1 REVISED PER ADDENDUM No. 1 DATED AUGUST 25, 2010

DESIGN BY J. Torkelson	CHECKED Tech Ngov	STATE OF CALIFORNIA DEPARTMENT OF TRANSPORTATION	DIVISION OF ENGINEERING SERVICES ELECTRICAL-MECHANICAL-WATER AND WASTEWATER DESIGN	BRIDGE NO.	STOCKTON MAINTENANCE STATION PHOTOVOLTAIC SYSTEM	SHEET EE-1
				29M5721		
DETAILS BY J. Kwong	CHECKED Tech Ngov	ORIGINAL SCALE IN INCHES FOR REDUCED PLANS	CU 10116 EA 0AA001	POST MILE	PARTIAL SITE PLAN	SHEET OF
QUANTITIES BY J. Torkelson	CHECKED Alan Torres			-		
DOES SD Imperial Rev. 10/09		0 1 2 3		REVISION DATES (PRELIMINARY STAGE ONLY)		24-AUG-2010 16:11
				DISREGARD PRINTS BEARING EARLIER REVISION DATES		ee_01.dgn

DESIGN	BY J. Torkelson	CHECKED Tech Ngov	STATE OF CALIFORNIA DEPARTMENT OF TRANSPORTATION	DIVISION OF ENGINEERING SERVICES	BRIDGE NO. 29M5721	STOCKTON MAINTENANCE STATION PHOTOVOLTAIC SYSTEM SINGLE LINE DIAGRAM - BLDG #4 & #6	SHEET
DETAILS	BY J. Kwong	CHECKED Tech Ngov		ELECTRICAL-MECHANICAL-WATER AND WASTEWATER DESIGN	POST MILE -		EE-3
QUANTITIES	BY J. Torkelson	CHECKED Alan Torres		CU 10116 EA 0AA001	DISREGARD PRINTS BEARING EARLIER REVISION DATES		10/2/09

PARTIAL SITE PLAN
SCALE 1" = 20'-0"

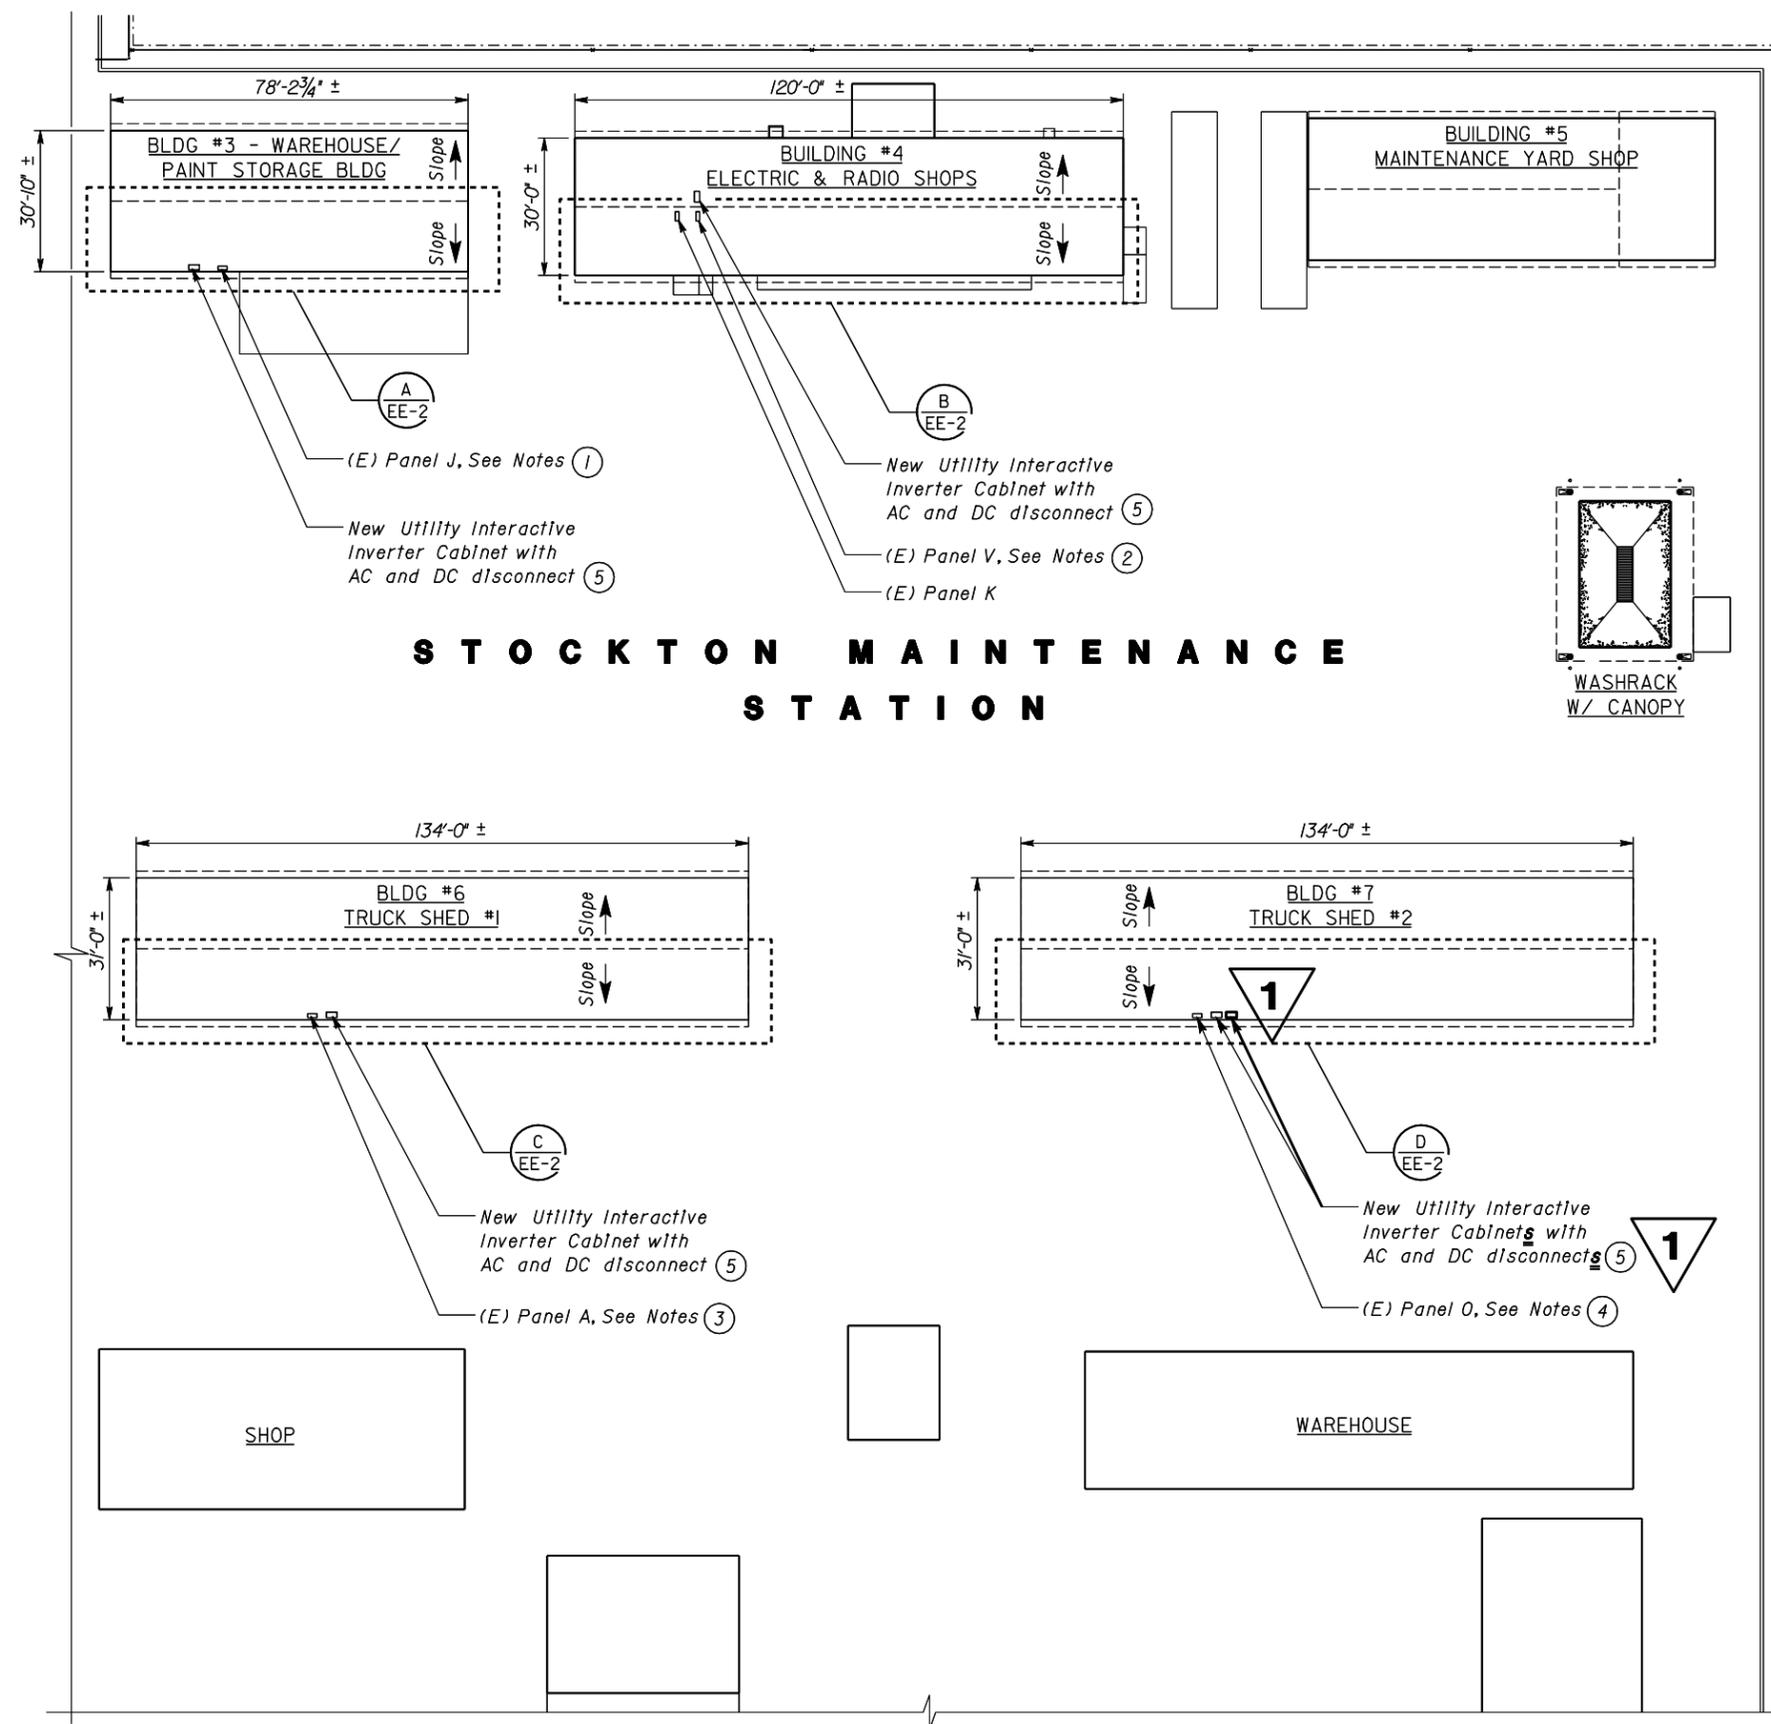
- Notes:**
- (E) Panel J is a wall mounted 100-Ampere, 120/240-volt, single-phase panelboard fed from Panel K in Building #4. There is a 100-Ampere fused disconnect switch mounted next to Panel J. Replace the (E) disconnect switch with a new 100-Ampere fused, two-pole disconnect switch with the required multiple load side lugs to feed (E) Panel J and the new Utility Interactive System. See sheet ~~EE-3~~ EE-4

- (E) Panel O is a wall mounted 125-Ampere, 120/240-volt, single-phase panelboard fed from Panel K in Building #4. Intercept the conduit feeding Panel O and install a new 100-Ampere, two-pole fused disconnect switch with the required multiple load side lugs to feed (E) Panel V and the two new Utility Interactive Systems. See sheet ~~EE-3~~ EE-4

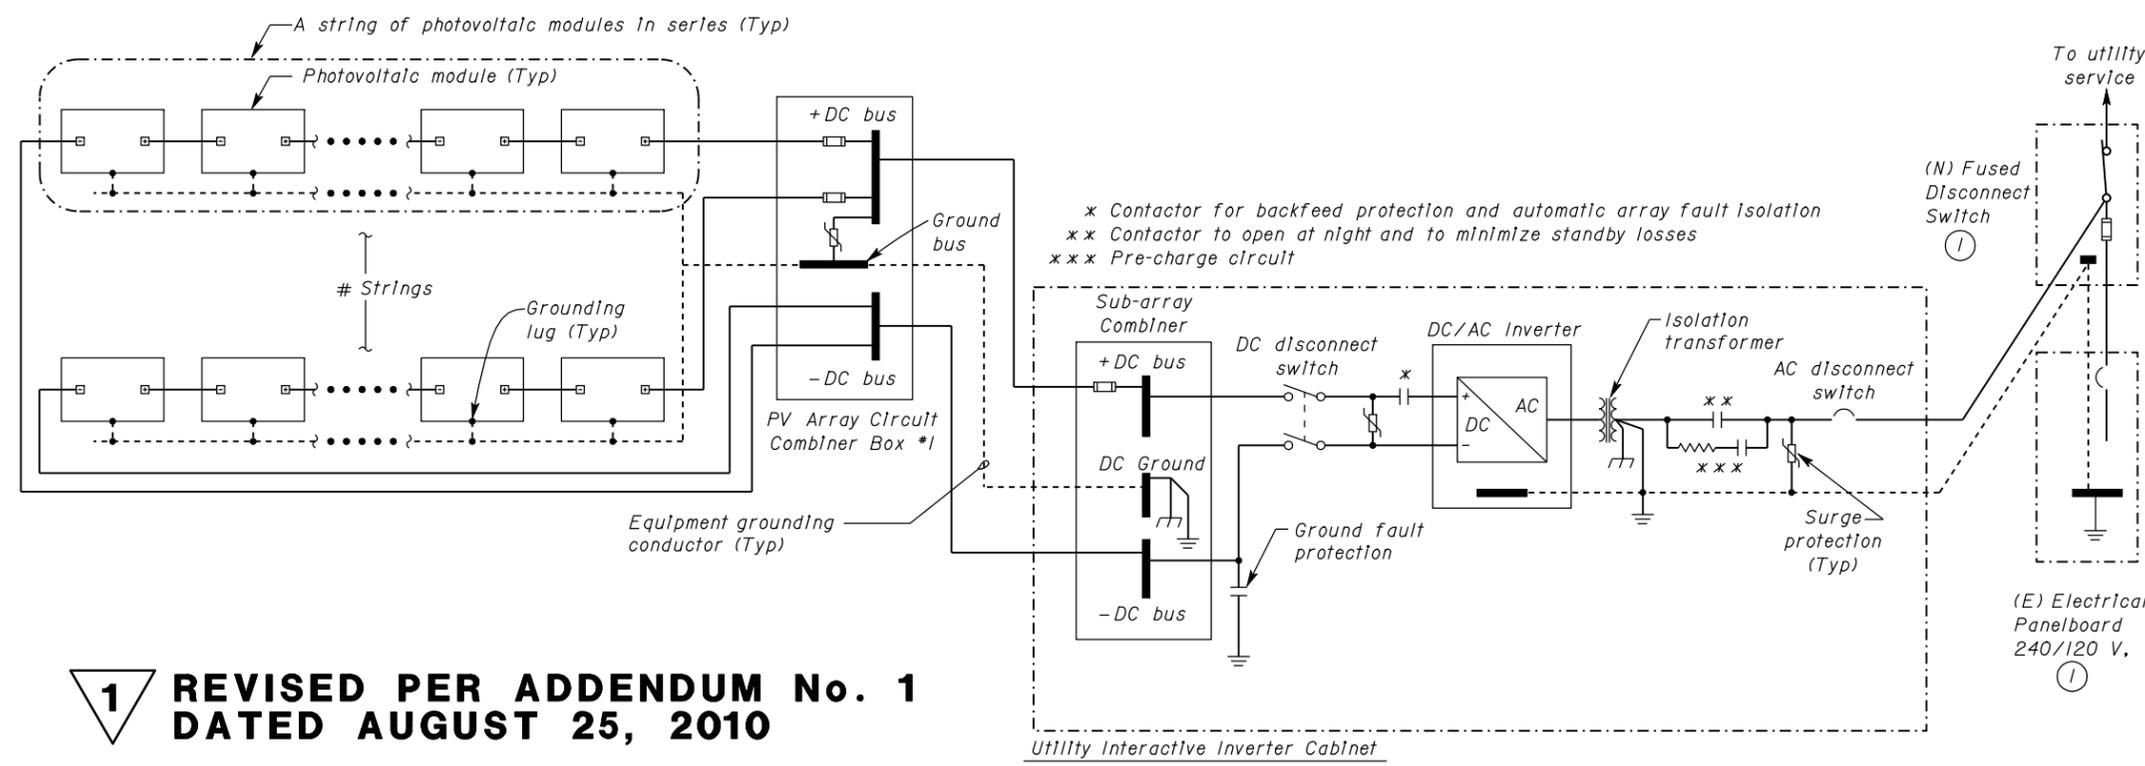
- Built-in DC and AC disconnect switches, size to match loading.
- Integrated ~~15~~ 15 kVA, 240/120 V, 3-phase, 4-wire, output isolation type transformer.

- Total designed capacity of photovoltaic system at existing Building shall have CEC-AC rating of ~~12.5~~ 12.5 kW. Number of PV modules per string shall be arranged in a manner to meet or exceed the following:

1 REVISED PER ADDENDUM No. 1 DATED AUGUST 25, 2010

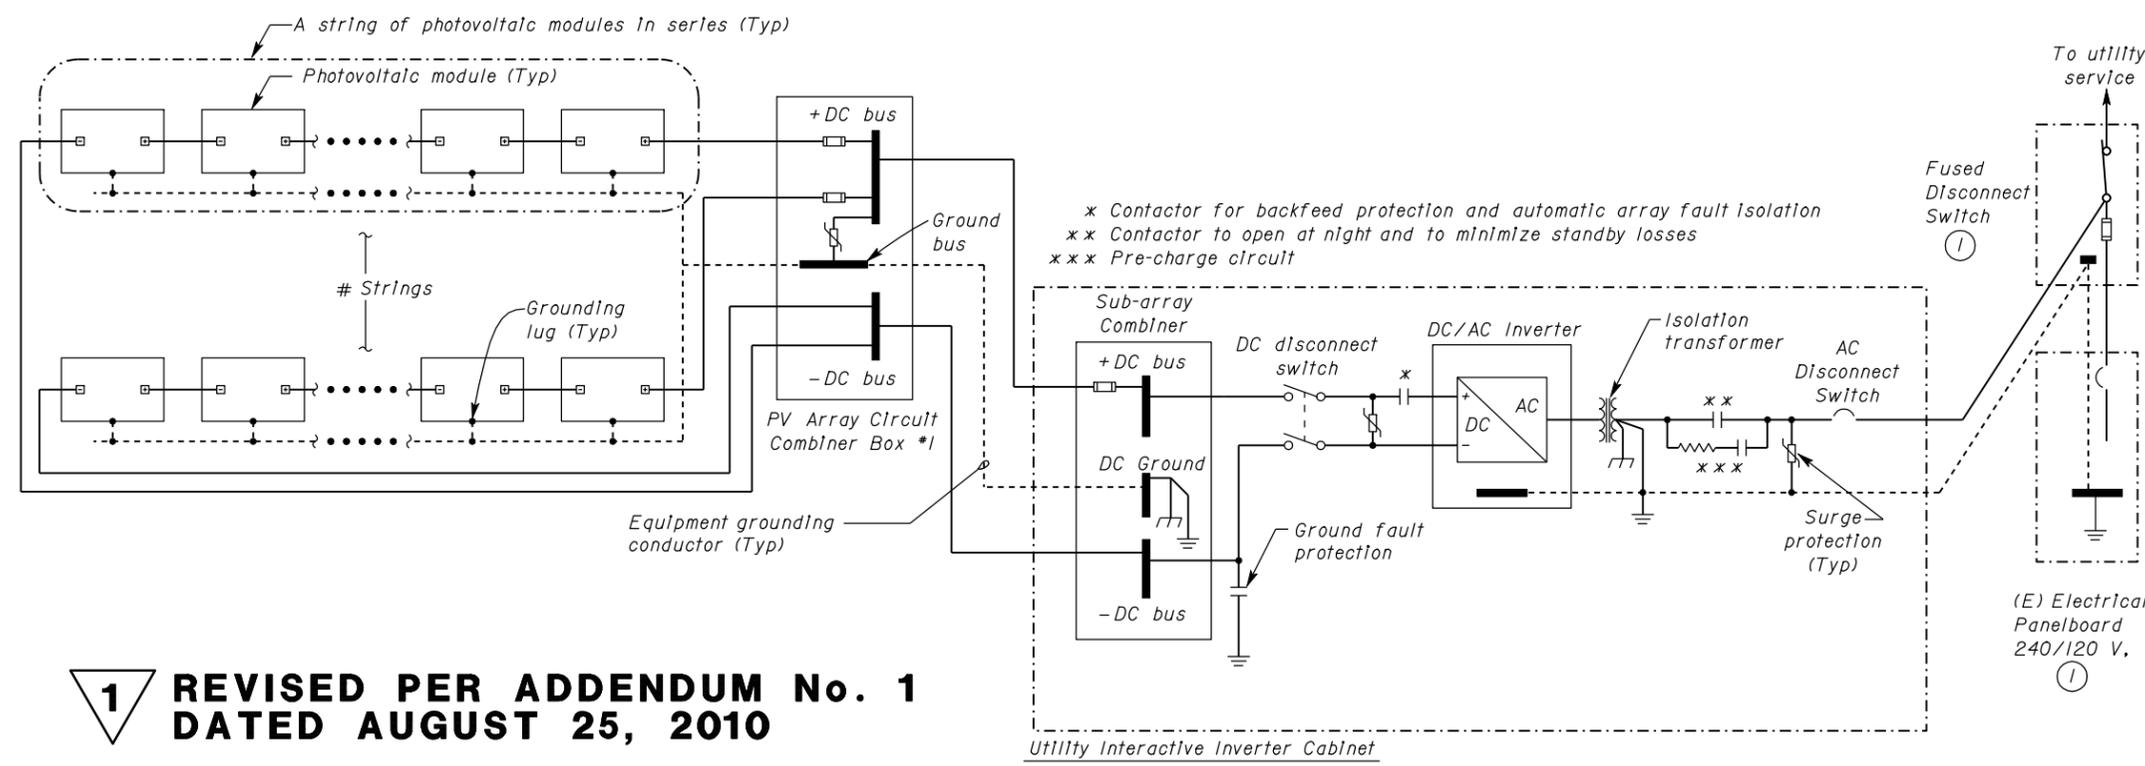
- Built-in DC and AC disconnect switches, size to match loading.
- Integrated 5kVA, 240/120 V, ~~3-phase~~, **1-phase, 3-wire**, output Isolation type transformer.

1 REVISED PER ADDENDUM No. 1 DATED AUGUST 25, 2010
